Service Bulletin
Maintenance of Way Equipment

Date: 3.11.2025   **RRP Service Bulletin No:**   RRP SB396

Title: Gasket orientation when replacing the 472046 control valve (used to dump the brakes).

Wrong Orientation

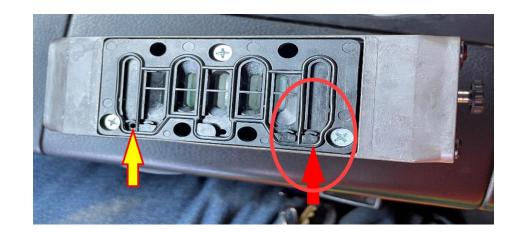
Arrows indicate the locations of additional ports manipulated by the gasket.

The red arrow indicates port blocked per vendor installation.

This will cause the dump valve to bypass and not operate properly.

Correct Orientation

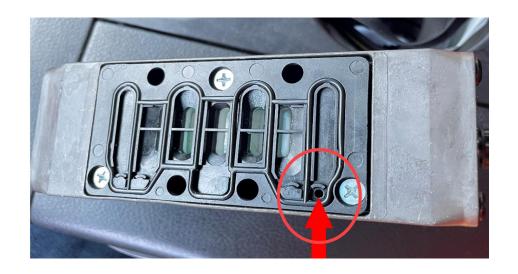
The red arrow indicates the correct orientation of the gasket.

The open port on the coil end.

Action: Reinstall the gasket in the correct orientation. If the machines are functioning normally there is no action needed.

Completion / Resolution: Continue with normal machine operation after installing the parking brake dump valve gasket in the correct orientation.
